ADDENDUM NO. 3

TO: PLANS AND SPECIFICATIONS FOR STATE OF MISSOURI

Lewis and Clark State Park - New Premium Campsites Missouri State Parks West Region Rushville, Missouri PROJECT NO.: X2219-01

CAMPER SEWER CONNECT (4" SEWER LINE)

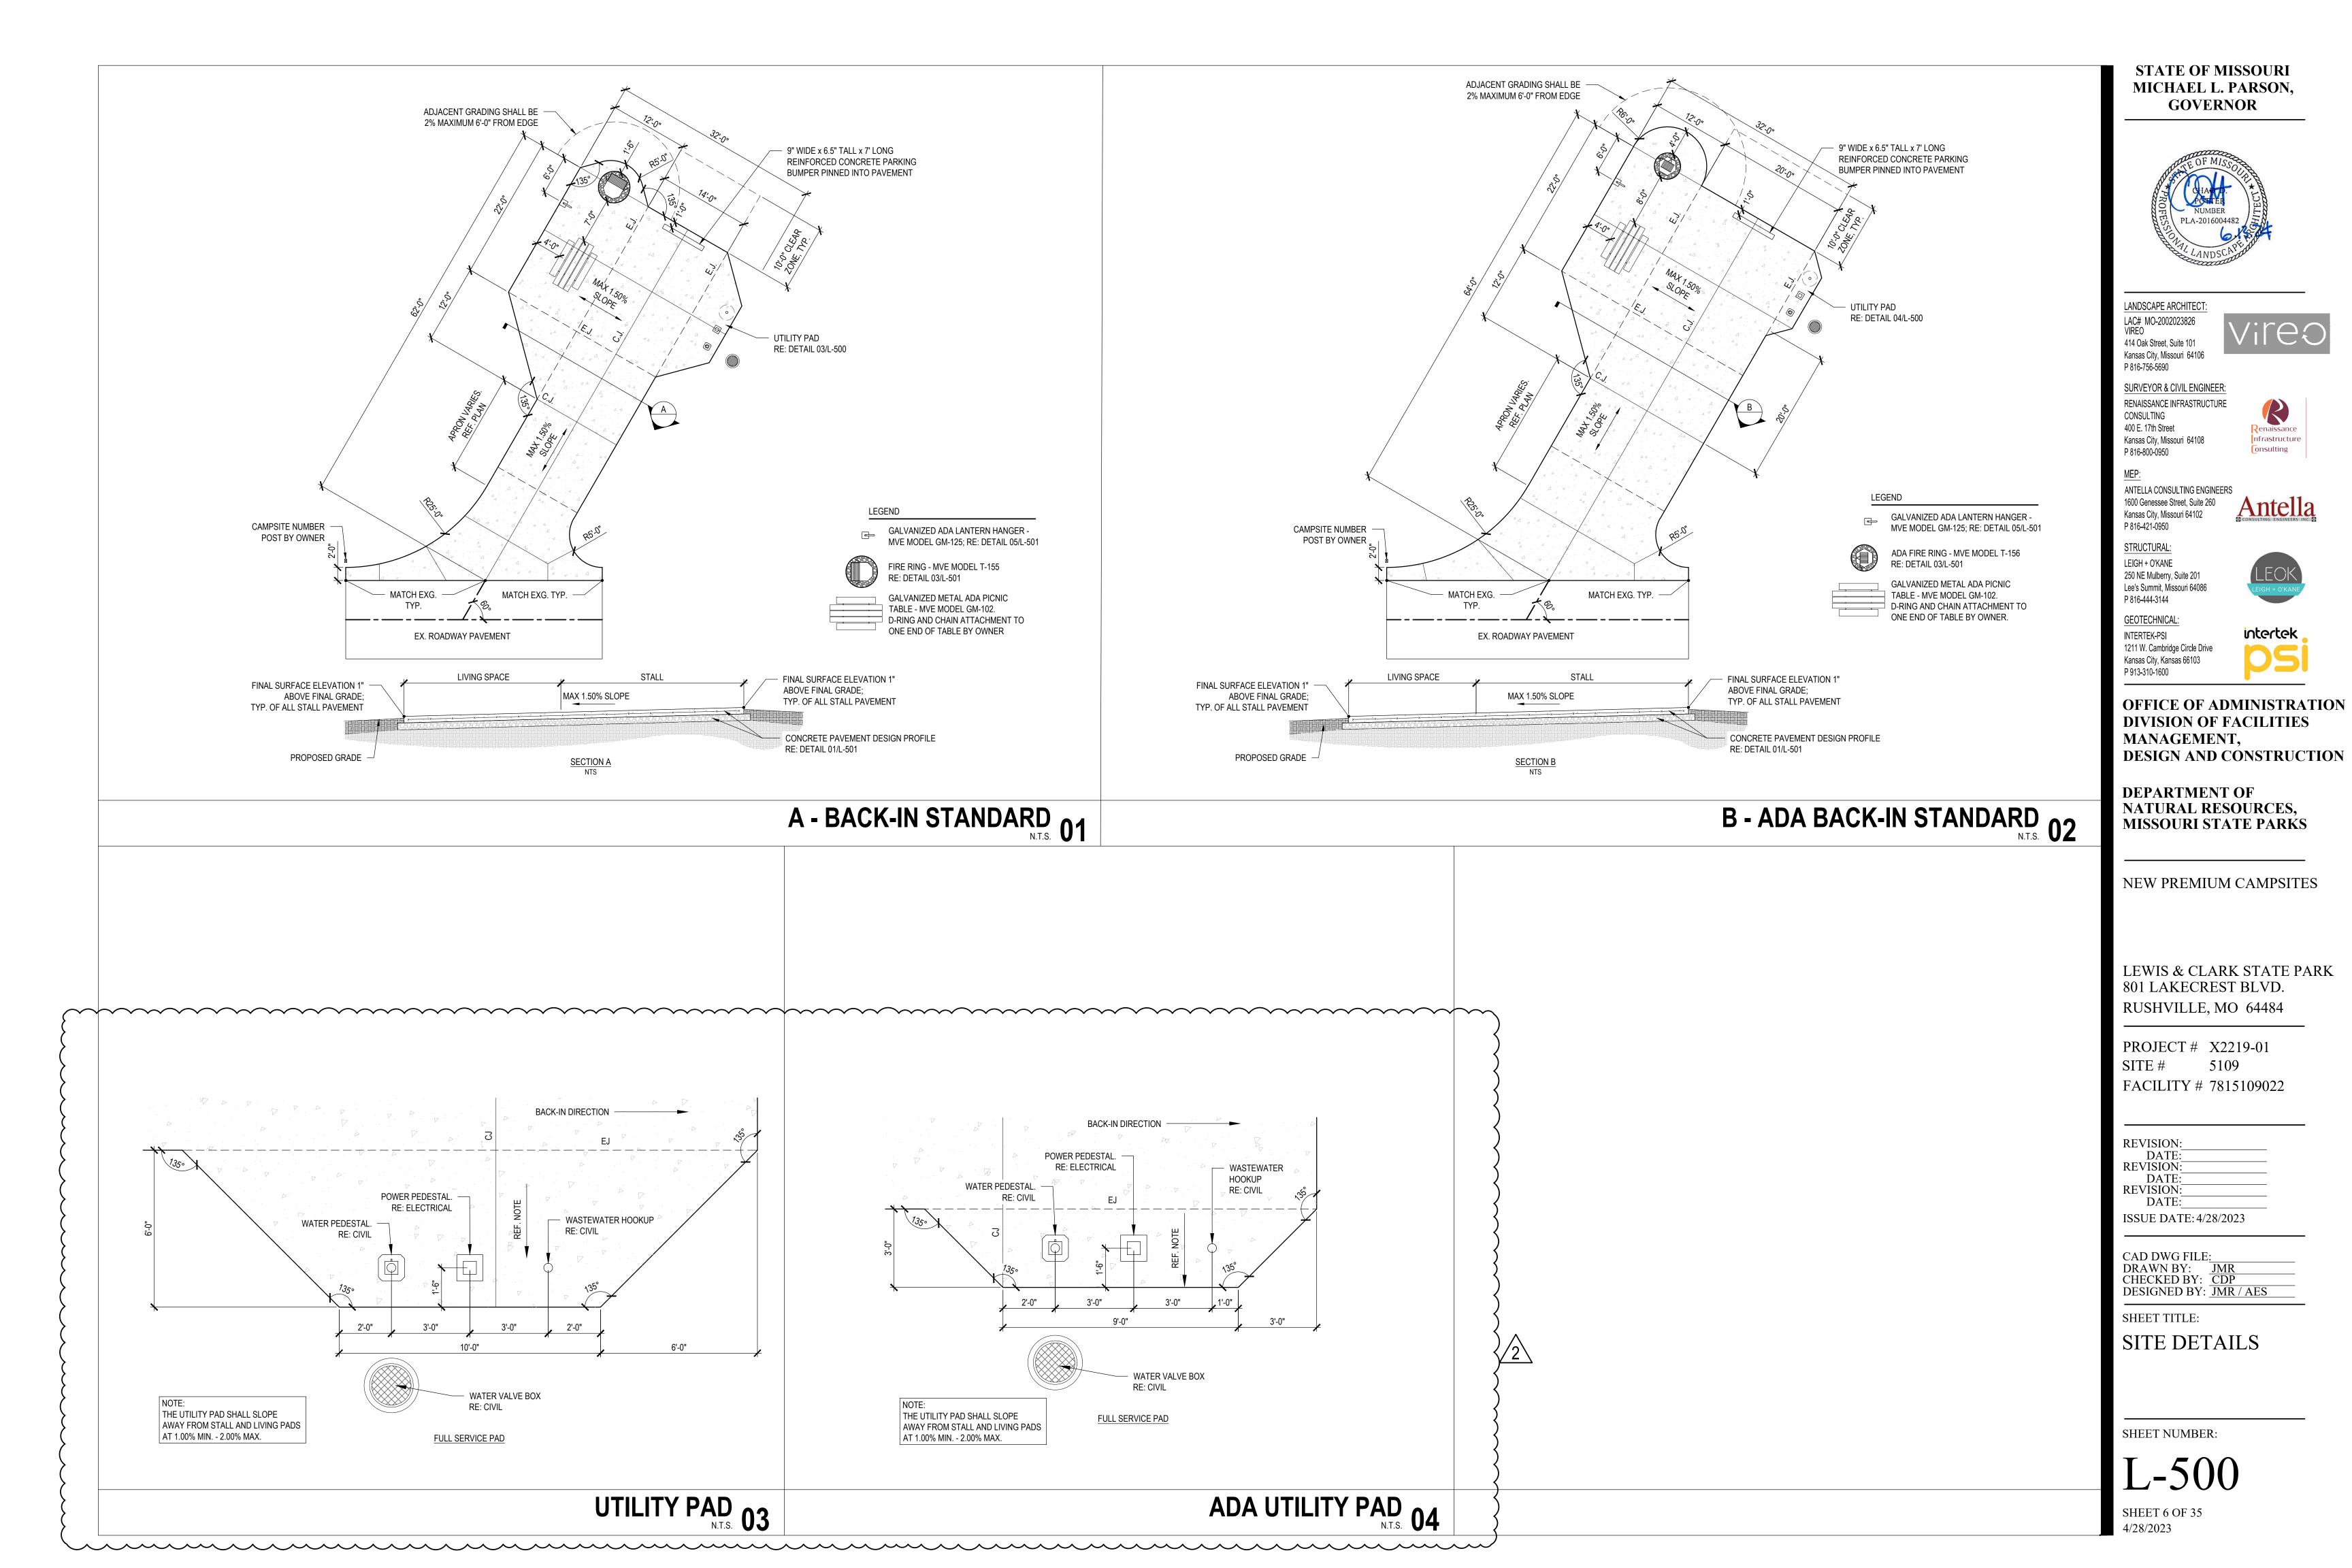
- 1. **Sheet L-500**, refer to revised details 3 and 4 attached. Concrete for utility pads is to drain away from centerline of campsite.
- 2. **Sheet C-506** replace the existing sanitary stub detail. See attached
- 3. **Sheet E-801** clarifications regarding coordination with Evergy. See attached.
